Monticello Nuclear Generating Plant
Docket 50-263
License No. DPR-22

Response to Request for Additional Information Regarding Intake Structure Pump
Room Exemption Request (TAC No. MC1803)

NUCLEAR MANAGEMENT COMPANY, LLC (NMC) RESPONSES TO NRC REQUEST FOR ADDITIONAL INFORMATION

FIGURE 1
FIRE ZONE 23-A

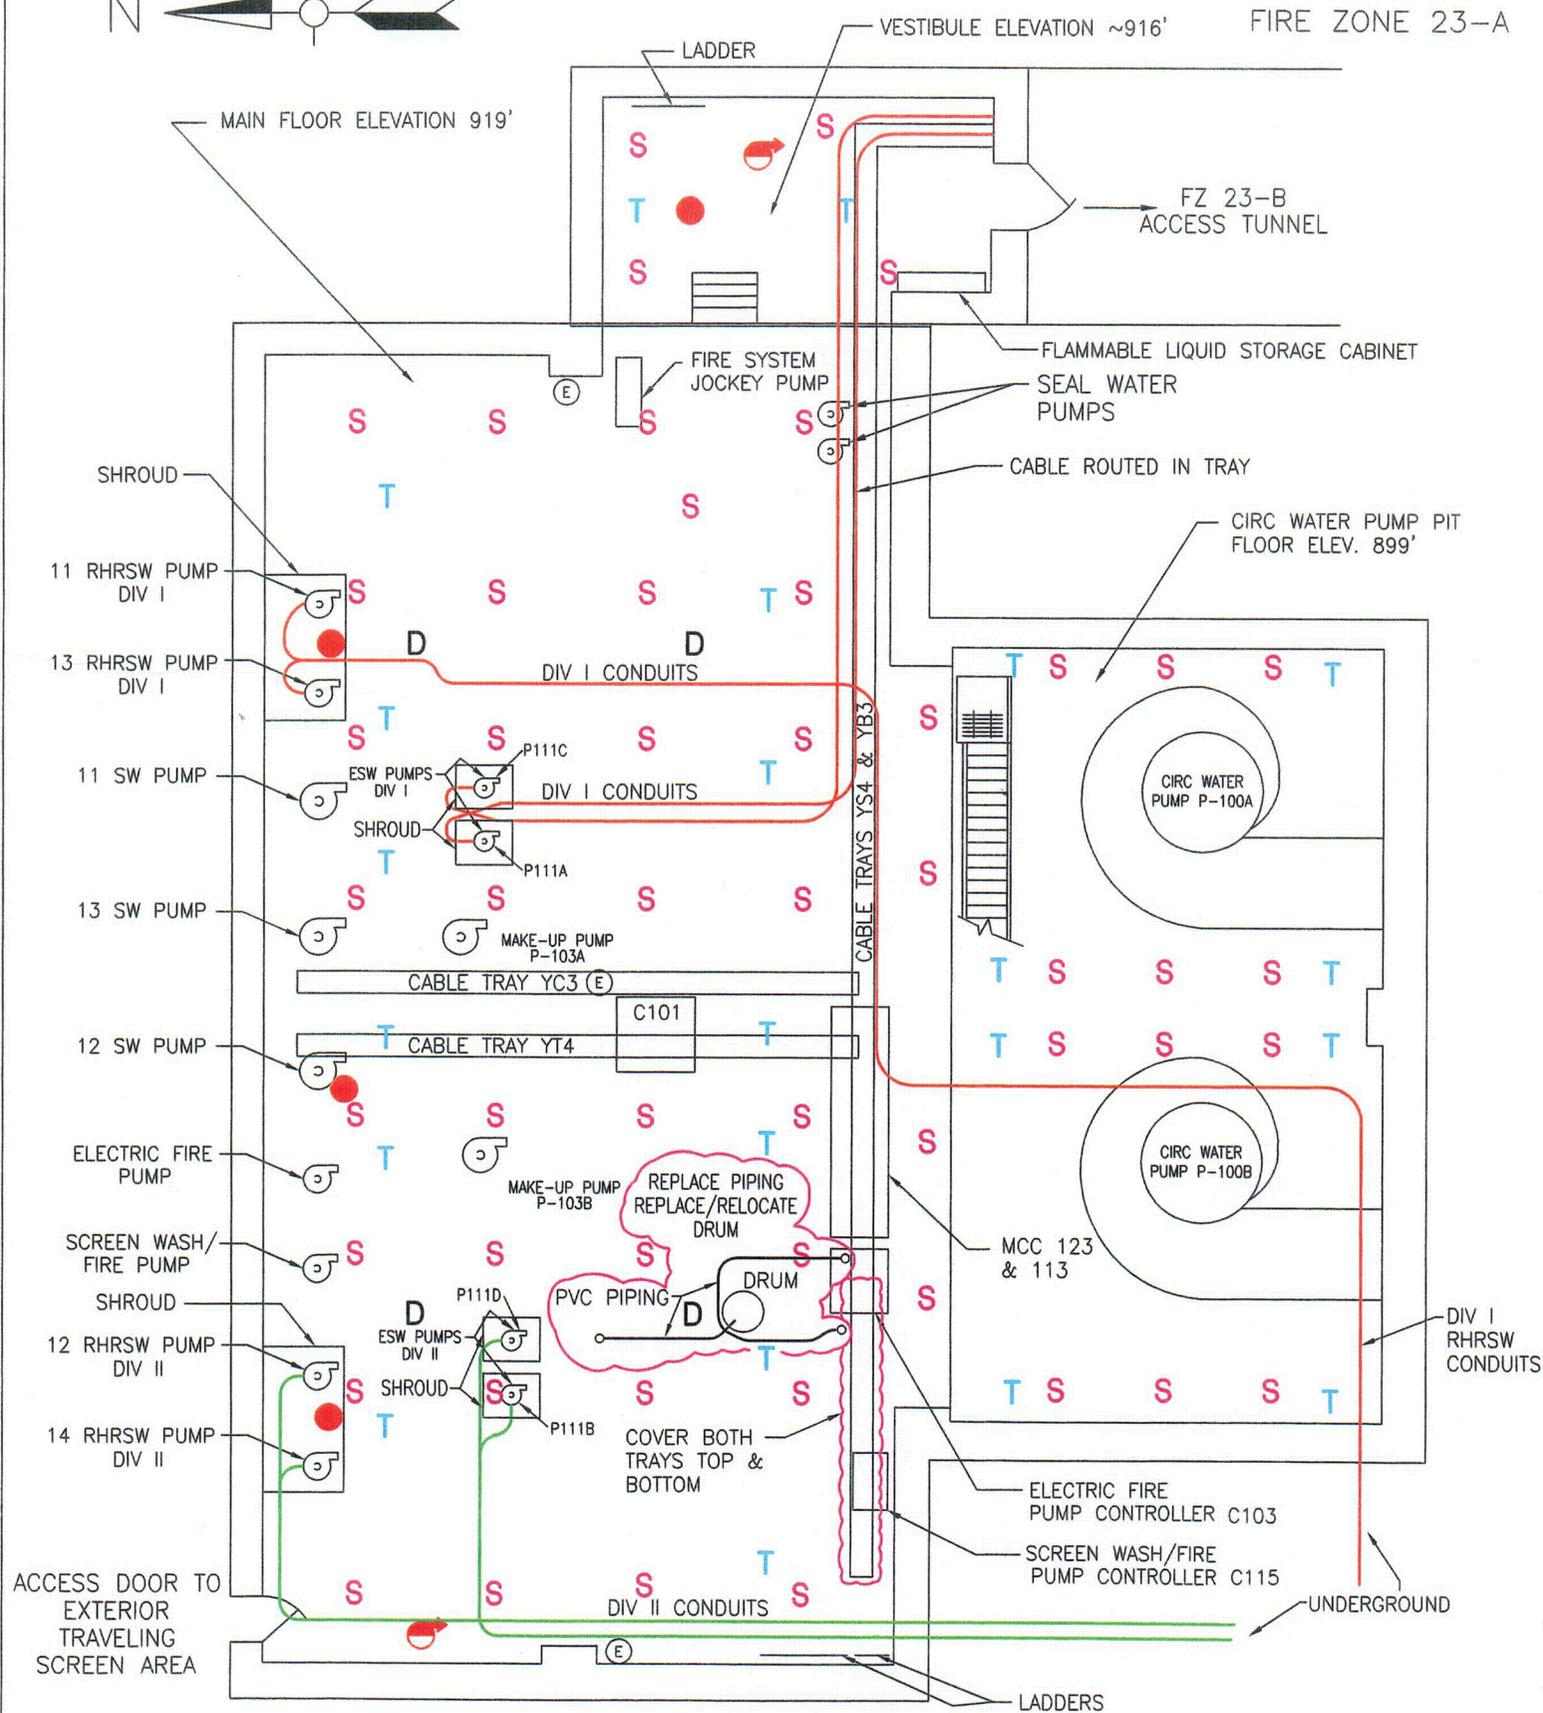
Three ladders are stored in the Intake Structure Pump Room (locations identified on Figure 1) and are classified as transient combustibles due to their portable nature. The combustible loading of the ladders results in an estimated loading of 250 BTU/sq. ft. (1M BTU total), or an equivalent fire severity of less than 1 minute.

In Reference 1, Enclosure 1, Section C.5.c and Figure 1, NMC identified the type and location of portable fire extinguishers within the Intake Structure Pump Room. After further evaluation, NMC has determined that the current portable fire extinguishers required replacement. Therefore, the information contained in the applicable portion of Reference 1, Enclosure 1, Section C.5.c should be eliminated and the following information should replace it.

Figure 1 (provided in Enclosure 2) has also been modified to indicate only the location of portable fire extinguishers in the Intake Structure Pump Room. This revised Figure 1 supercedes the Figure 1 provided in Reference 1.

Structure Pump Room. This door is now considered an Access Door. Figure 1 and Reference 1, Enclosure 1, section C.2 described this door as an emergency exit. These are hereby revised.

Portable fire extinguishers in the Intake Structure are provided in accordance with the requirements of National Fire Protection Association (NFPA) 10, Standard for the Installation of Portable Fire Extinguishers. Extinguisher selection considers the type and size of fire hazards, as well as any chemicals, in the area.
